MEMORANDUM

DATE: November 15, 2012

FROM: Christian R. Petrich, Ph.D., P.E., P.G.

RE: *Response to IDWR Staff Memo regarding the sufficiency of water supply for water right applications and transfers along the I-84 corridor*

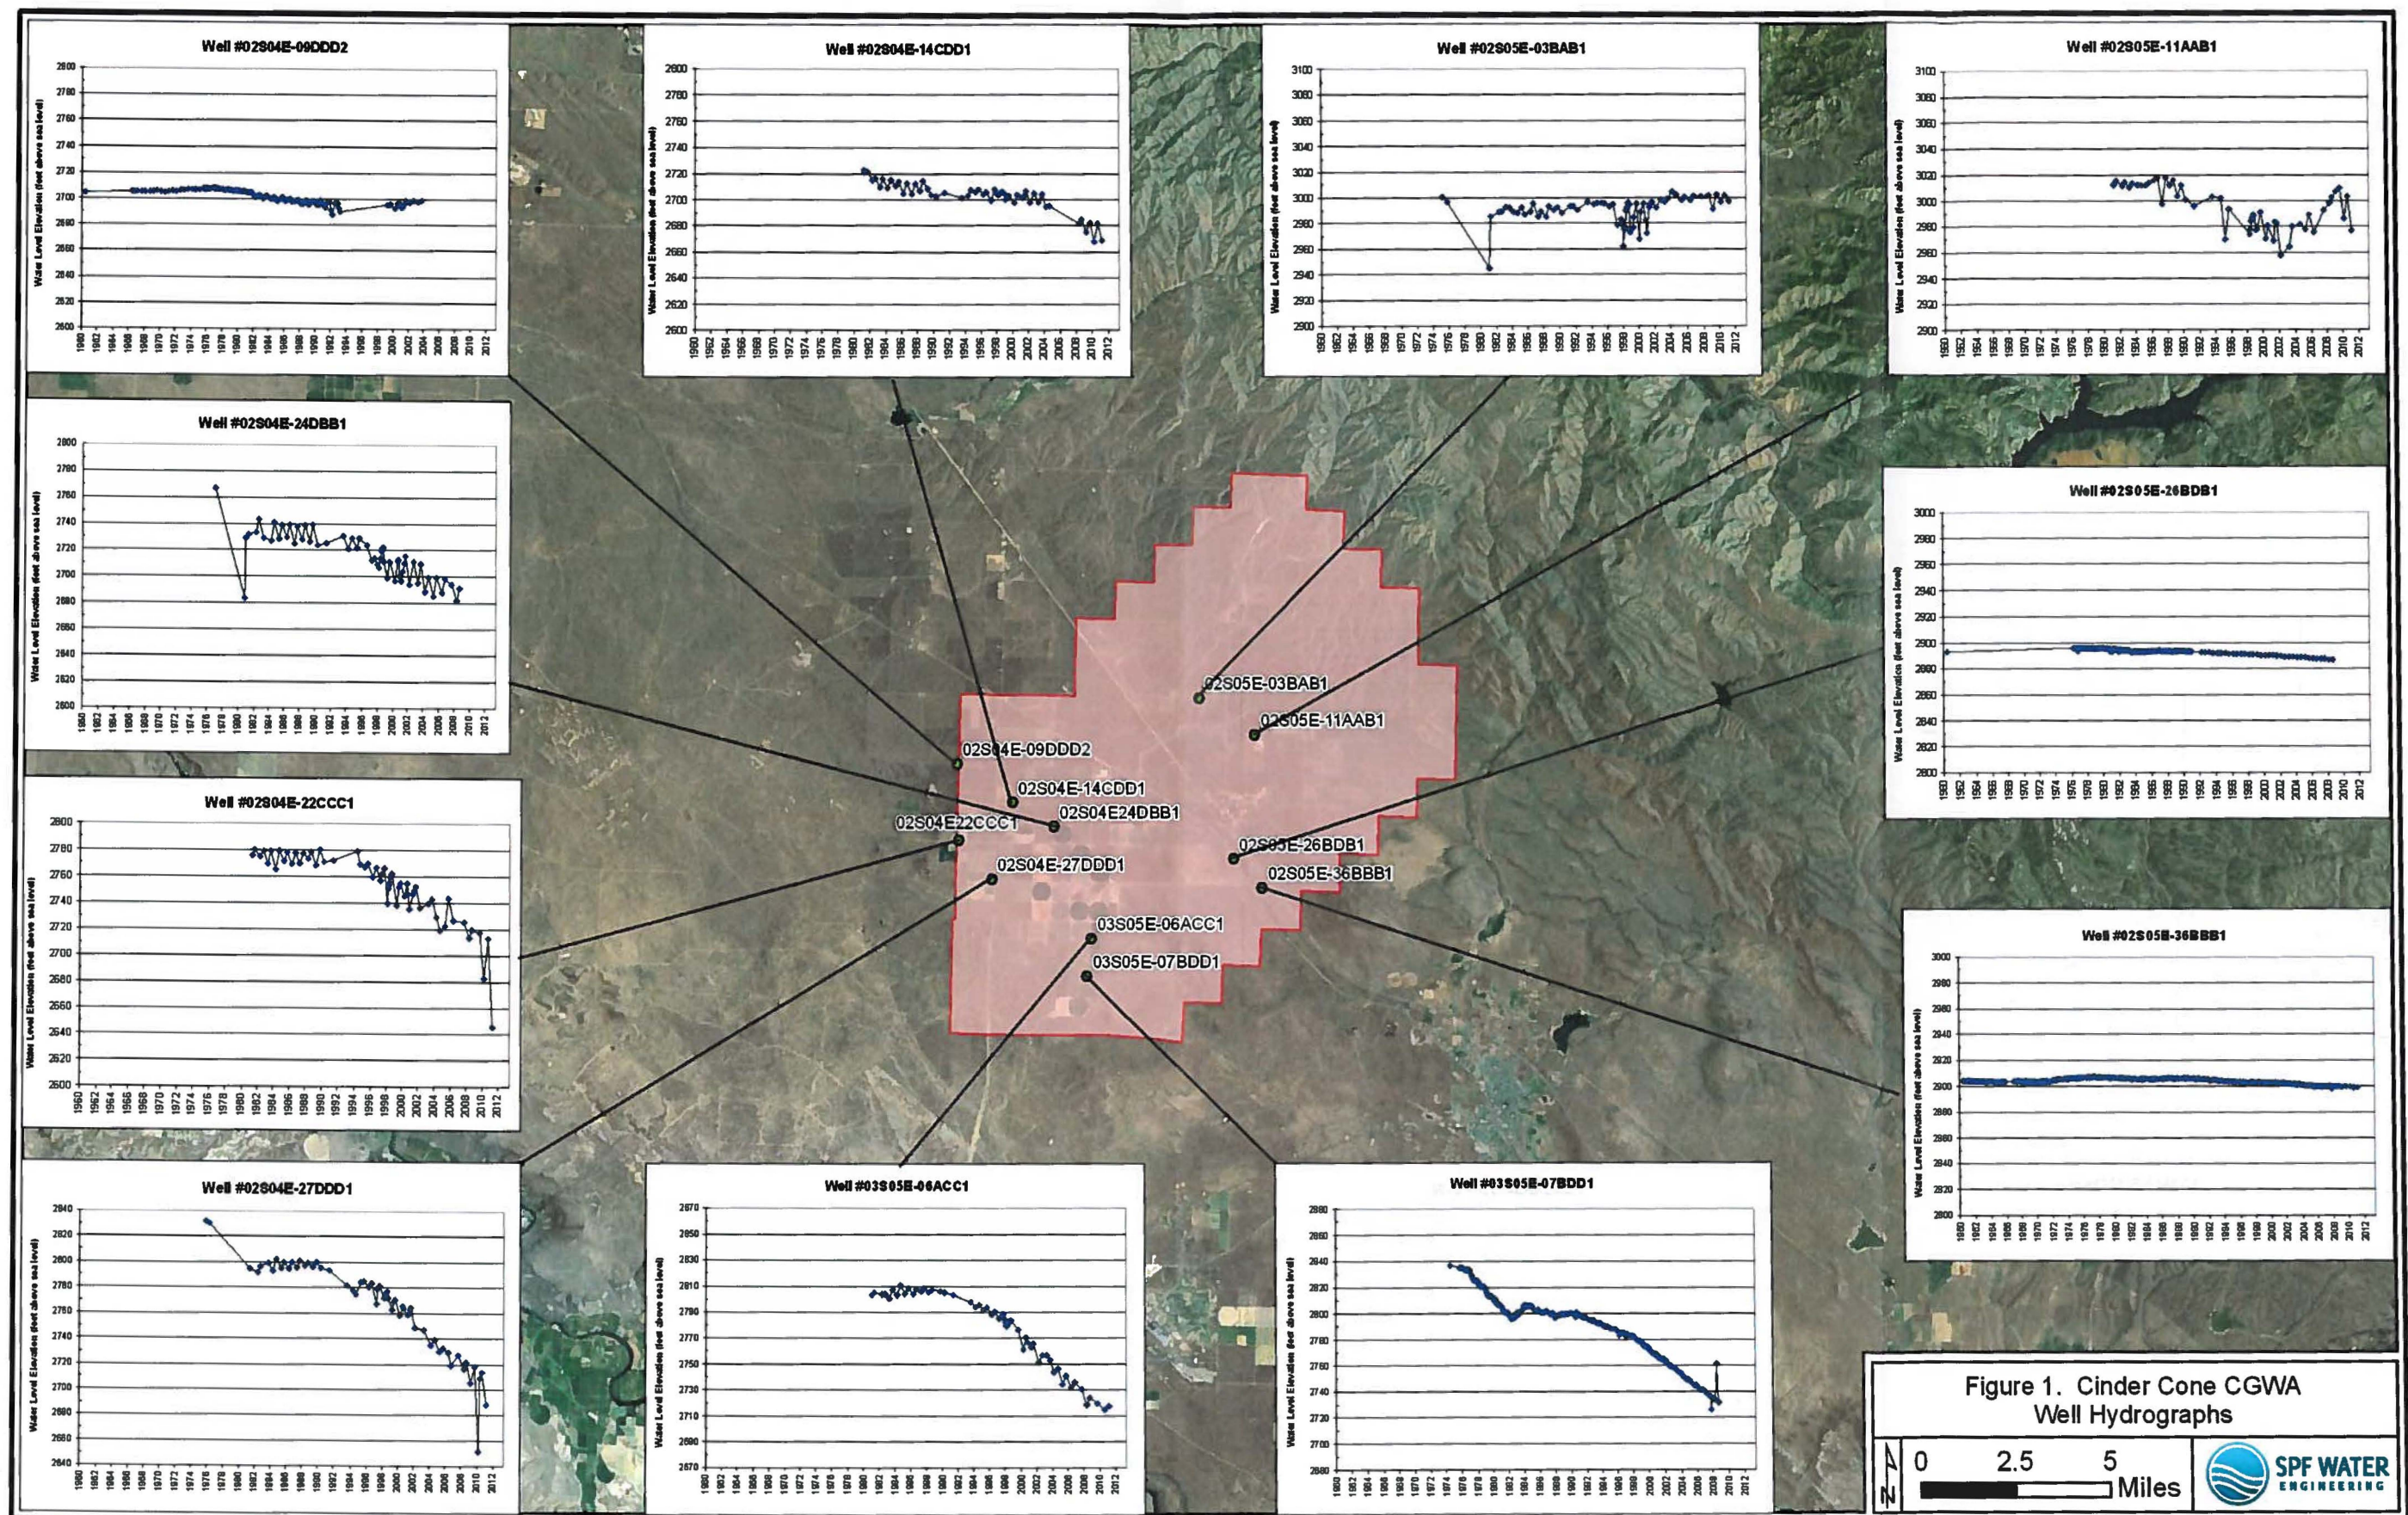
8. The Staff Memo¹¹ presents hydrographs for the Cinder Cone Butte CGWA. A number of the hydrographs indicate similar downward trends. However, when re-

plotted with consistent y-scales the hydrographs show that the area of greatest declines is limited to the southern portion of the CGWA (Figure 1, page 15).
